CITY OF CARMEL-BY-THE-SEA HISTORIC RESOURCES BOARD

REGULAR MEETING Monday, November 20, 2023

SUBJECT: **DS 23-160 (Lutz)** – Request for reconsideration of a Determination of Consistency with the Secretary of the Interior's Standards issued by the Historic Resources Board on September 18, 2023, for Design Study application, DS 23-160 (Lutz), for additions, alterations, and site modifications including a kitchen addition, bedroom addition, and new detached garage in the front setback at the historic "Elizabeth F. Armstrong House," and a request to add the historic resource to the Carmel Register and creation of a design nonconformity (reduced composite side yard setback) located on Santa Fe Street 4 northwest of 6th Avenue in the Single-Family Residential (R-1) District. APN: 010-092-005-000.

GARAGE ROOF PLAN
1/4" = 1'-0"

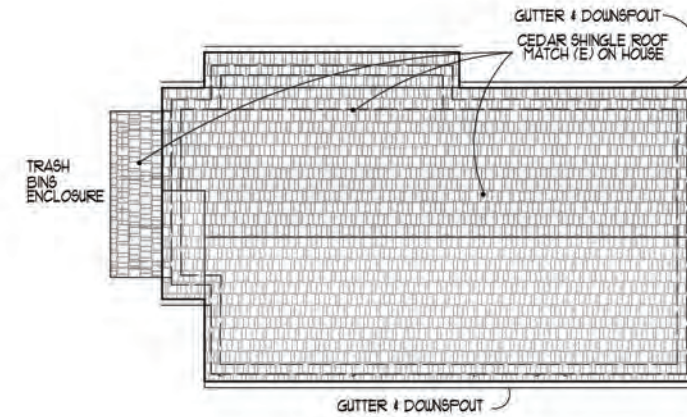
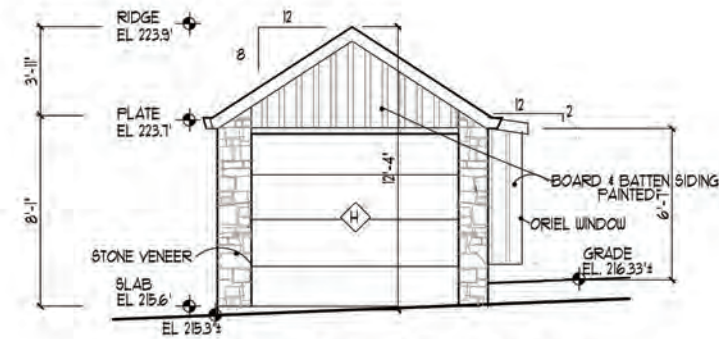
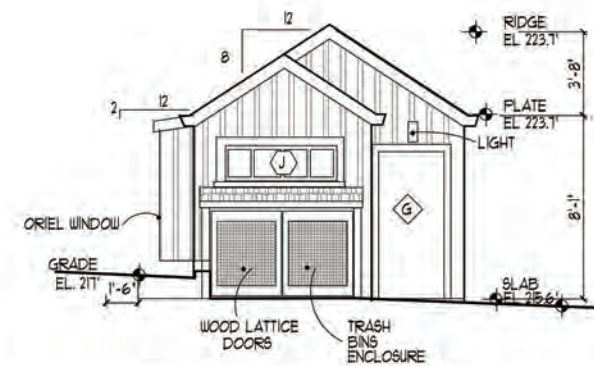
The applicant is requesting the Board reconsider the 250-square-foot garage, instead of the 200-square-foot garage deemed Standards-compliant on September 18th. Additionally, staff is recommending that the Board add the property to the Carmel Register for the purposes of accommodating a nonconforming composite setback created by the north bedroom addition. Per CMC 17.32.100.D, Benefits Available to Historic Resources on the Register, “design nonconformities shall be expanded or created only when this is found necessary to achieve consistency with the Secretary’s Standards.” Pushing the north addition west (as required by Resolution 2023-015) creates a nonconforming composite setback but is necessary to achieve consistency with the Secretary’s Standards.

Reduction in the garage size might provide a very small increase in the public view of the house. In fact, in designing the garage we accomplished that increase by recessing the door to the garage and "lopping off" the southwest corner of the garage that would potentially limit the view. The best view of the historic resource is from the southeast. It is an excellent view cone, and reducing the garage size will not significantly alter that view. In fact, too small a garage will force the Lutz's to park on the street, blocking view of the historic resource and defeating the purpose of viewing the property at all.

The Lutz's ask that the terms and conditions of the HRB Determination of Compliance be modified to allow for the originally designed 250 square-foot garage.

Staff Response: Staff recommends the proposed garage be reduced in size from 250 to 200 square feet (10 feet wide by 20 feet deep). At 250 square feet, the proposed garage will visually obscure more of the historic resource than if the size was reduced to 200 square feet. Staff recommendation is based on the City's municipal code, which identifies 200 square feet as the adequate size of a garage. A 200-square-foot garage would better preserve the historic site plan (a residence set back from the street with a large front garden area) and would be less detrimental to public visibility of the property than if the applicant were to construct the proposed 250-square-foot garage with a projecting bay window feature and a projecting trash enclosure (neither of which count towards the 250 square feet of garage floor area).

KEY PLAN - COMPOSITE SETBACKS

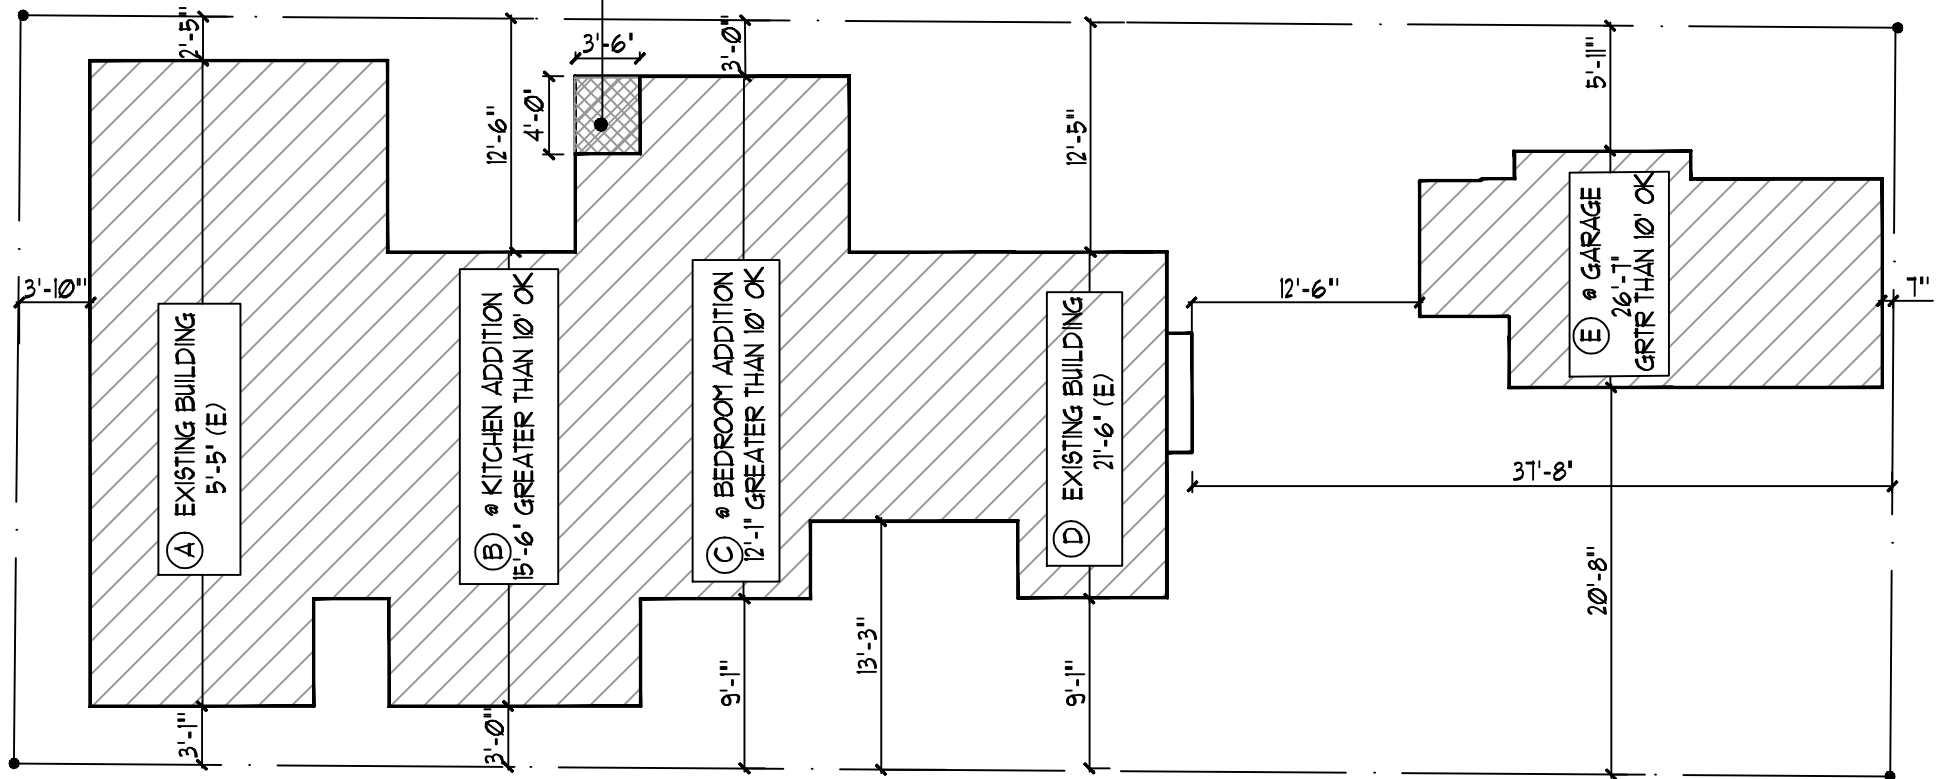
1. Addition of a waiver from the cumulative setback requirement to allow the bedroom addition to be moved to the west. The original proposed location of the northside bedroom addition was carefully crafted to meet cumulative setback requirements on both sides of the existing building. The historical consultant as well as planning staff have recommended relocating the bedroom addition to the west, to allow the existing north living room window to remain in place. And several Board members, in discussion of the project in the hearing, indicated a preference for moving the addition to the west.

REQUEST FOR WAIVER:
 WAIVER FROM CUMULATIVE SET-
 BACK REQUIREMENT TO MEET
 HISTORIC RESOURCE BOARD
 REQUIREMENT FOR CERTIFICATION
